Product Change Notification

Date Issued :	August 18, 2023	PCN Number :	514062
Reason for Change :	Change to Product		
Description of Change :	Molex is introducing a slight geometry change (relief slot) to the MX150 product family to eliminate the need for moisture conditioning the connector housing prior to the finished goods assembly process.		
Reason for Short Notice :	Special Request		
Assessment of Change :	Dimension analysis		
Planned Implementation Date :	April 04, 2024		
Sample Availability Date:	November 03, 2023		
Internal Molex Qualification Date :	November 10, 2023		
Last date to request Samples by Customer :	September 15, 2023		
Traceability Code Markings / Date :	No special marking on the product or packaging

Before Picture

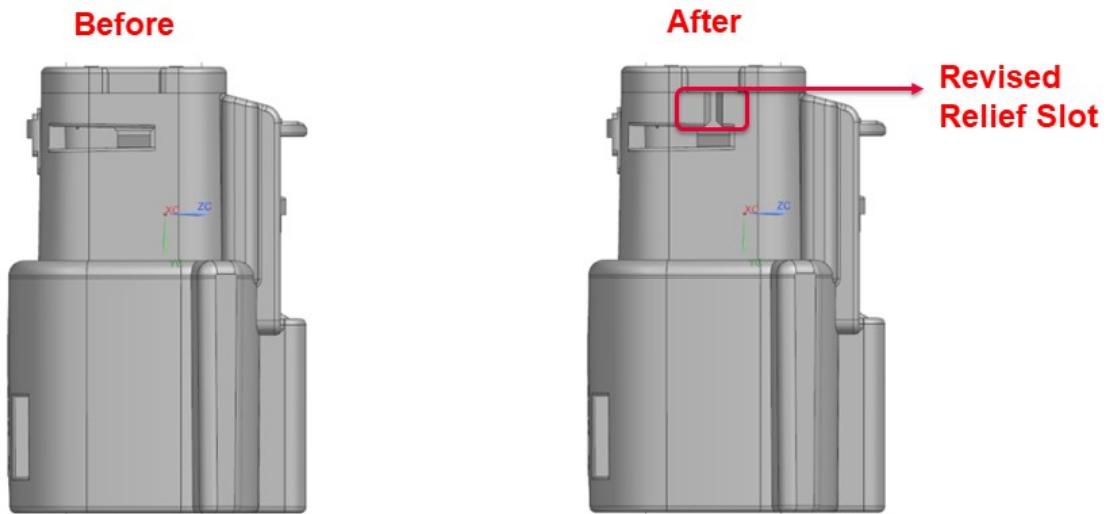
- Molex is introducing a slight geometry change (relief slot) to the MX150 product family to eliminate the need for moisture conditioning the connector housing prior to the finished goods assembly process. Refer to existing and revised housing geometry shown.

- The existing connector housing design requires moisture conditioning to avoid damage during the assembly process. The revised design is a permanent change that eliminates the potential damage and the need for moisture conditioning.

- There is no impact to part fit or function. There is a visual difference between the existing and revised connector housing where plastic has been removed for the relief slot.
